<b>Project</b>	<b>IEEE 802.16 Broadband Wireless Access Working Group</b>	
<b>Title</b>	<b>UL Access Zone BW Request for Distributed RS</b>	
<b>Date:</b>	<b>04-25-2007</b>	
Source(s)	Eugene Visotsky <a href="mailto:eugenev@motorola.com">eugenev@motorola.com</a> Roger Peterson Motorola Labs 1301 E. Algonquin Road, Schaumburg, IL 60196 USA	Shyamal Ramachandran <a href="mailto:shyamal.ramachandran@motorola.com">shyamal.ramachandran@motorola.com</a> Motorola Inc. 1064 Greenwood Blvd. Suite 400 Lake Mary, FL 32746 USA
Re:	This document is in response to call for technical proposals IEEE 802.16j-07/013 dated 04/02/2007. This document proposes text regarding signaling for efficient routing for insertion in baseline document IEEE 802.16j-06/026r3.	
Abstract	This contribution proposes signaling to enable UL Access Zone BW Request from an RS to an MR-BS with decentralized scheduling.	
Purpose	Text is included for insertion in the IEEE 802.16j amendment to the standard.

# UL Access Zone BW Request for Distributed RS

Figure XXX – RS UL\_AZ Request Header

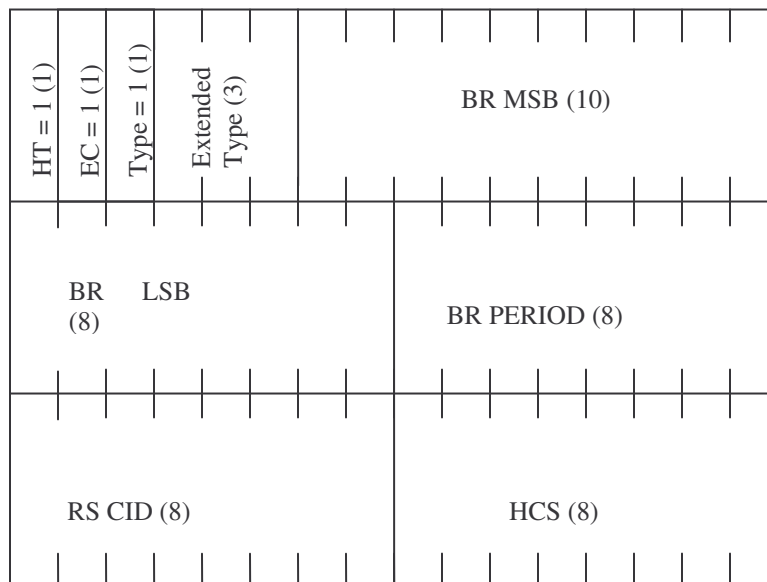
[Insert new subclause 6.3.2.1.2.2.3 as follows:]

6.3.2.1.2.2.3 RS UL AZ Request Header

An RS may optionally request BW for its access zone from the superordinate RS/MR-BS by sending the RS UL\_AZ Request Header. The header specifies the requested size of the RS access zone in ODFMA slots. The header also specifies the periodicity in frames of the access zone BW request. The header is as follows:

Table XXX - Description of fields in Relay Access Zone Bandwidth Request header

<u>Name</u>	<u>Size</u>	<u>Description</u>
<u>BR</u>	<u>18 bits</u>	<u>Bandwidth Request: The number of OFDMA physical layer slots requested for the RS access zone</u>
<u>BR PERIOD</u>	<u>8 bits</u>	<u>Indicates periodicity in frames of the access zone BW request</u>
<u>CID</u>	<u>8 bits</u>	<u>Reduced Basic CID of the RS</u>
<u>HCS</u>	<u>8 bits</u>	<u>Header Check Sequence (same usage as HCS entry in Table 5).</u>
